EXPERT OPINION – GLENCORE GLENDELL CONTINUED OPERATIONS COAL PROJECT

This letter has been prepared in response to a brief (the Brief) from Environmental Defenders Office (EDO) dated 9 March 2022. The Brief requests review of various documents in relation to the Glencore Glendell Continued Operations Coal Project (The Project) and to provide a report which addresses the following issues in regard to any groundwater and/or surface water impacts arising as a result of the Project:

Figure 4 – Extents of “highly productive groundwater”, as gazetted (left – shown as blue hatch) and as interpreted by the Proponent (right – shown as yellow) (Figures taken from Appendix 16 of the EIS)

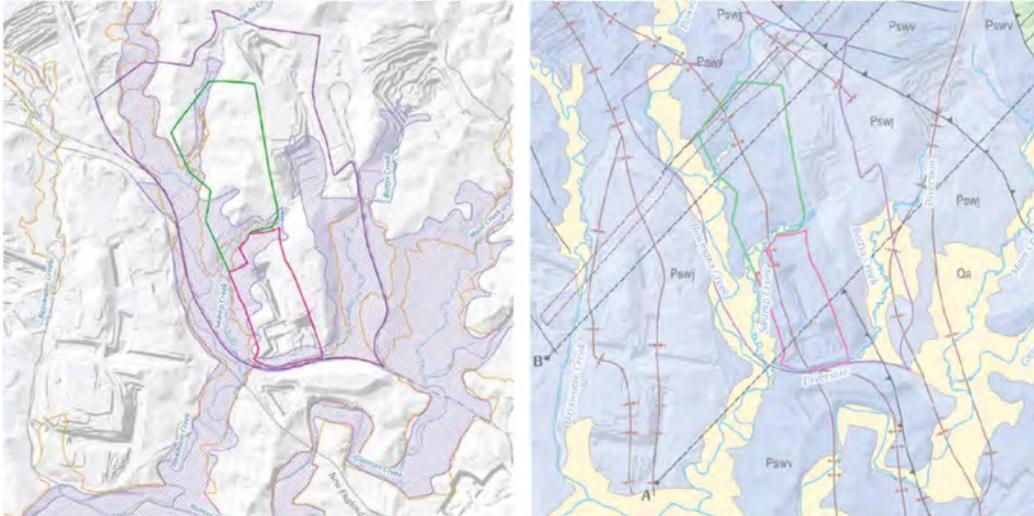
The physical removal of material from the pit is set out in mine plans. The planned extent of the pit is not reviewed in this present report. However, the EIS argues for reducing the interpreted extents of the alluvial groundwater resources, thereby reducing the interpreted volume of these "highly productive groundwater" resources that is removed. This argument by the Proponent is based upon the undertaking and interpretation of a number of test pits around the periphery of the mapped alluvium (in the vicinity of the Project) by the Proponent. The resulting re-interpreted extents of "highly productive groundwater" is reproduced in Figure 4.

Firstly, the Proponent has taken liberty to greatly reduce the mapped extent of these “highly productive groundwater” resources. The basis of this reinterpretation is test pits, but to my understanding the test pit logs (which typically include photographs) are not presented in the EIS for review, and the interpretation of the extents of the alluvium was not subjected to peer review. In my view, test pits logs should be presented in the EIS, and it is unclear to me if the reduced extents of mapped alluvium by the Proponent can be considered authoritative without independent review.

Figure 6 – Details of numerical groundwater flow model in the vicinity of the Project (taken from Figure B3 of Appendix 16 of the EIS)

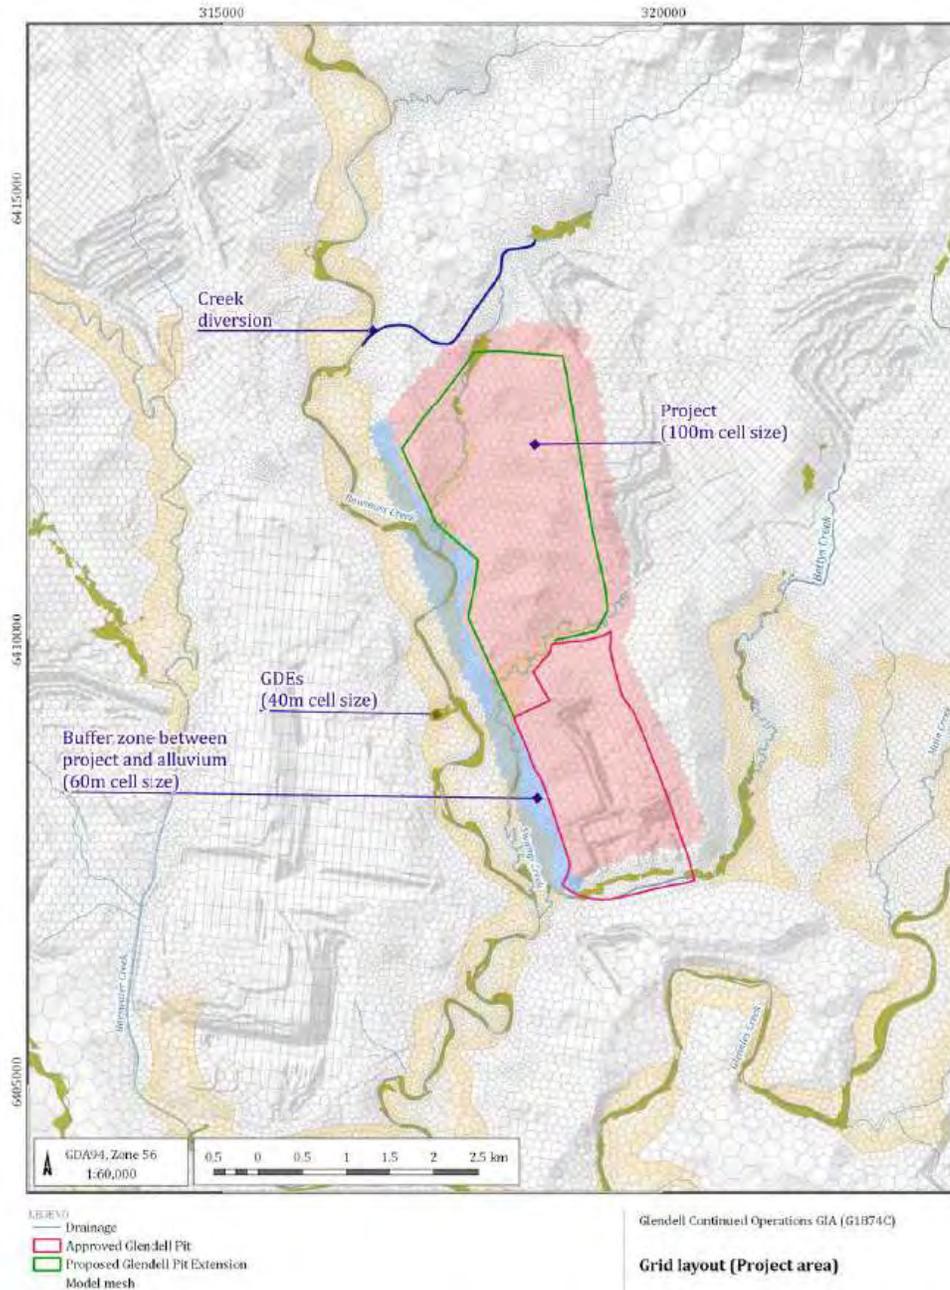
Secondly, the regional groundwater flow model does not have the necessary resolution to examine groundwater processes in the alluvium with accuracy. Based on information presented in the EIS (e.g. Figure 6), a 40-m grid size (or so) is not adequate to simulate detailed exchange of flows with streams, and in my understanding the alluvium is represented with a single model layer, which does not allow detailed examination of changes to pressure and saturation within the alluvium. I do not argue that a regional groundwater model should attempt to represent such detailed processes, but I argue that a more detailed sub-study (e.g. a localised model) could be adopted to examine these processes.

Figure 7 – Example of a cross-section that could be presented in the modelling report (alluvium extents shown in green)

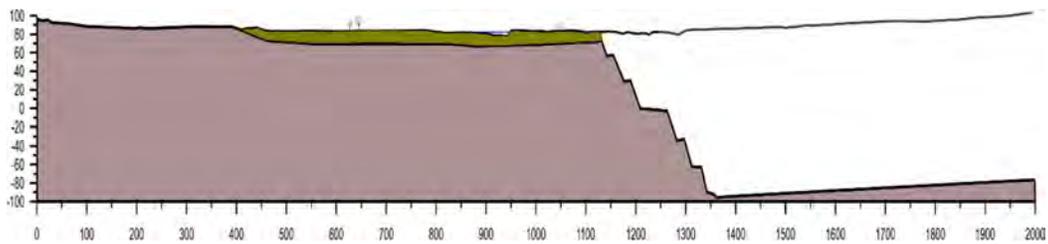
Thirdly, the groundwater modelling the EIS does not clearly represent details of the alluvium regions. For example, I have drafted an approximate cross-section for this Project (Figure 7), showing the extents of alluvium at a particular location relative to the proposed pit extension. I argue that such a cross-section, taken from the numerical model, should be presented. Such a cross-section would illustrate clearly the resolution to which this alluvium has been physically represented within the numerical grid. It could also be used to present simulated groundwater depressurisation in detail, which would allow examination of why such a small amount of depressurisation is realised within the alluvium.
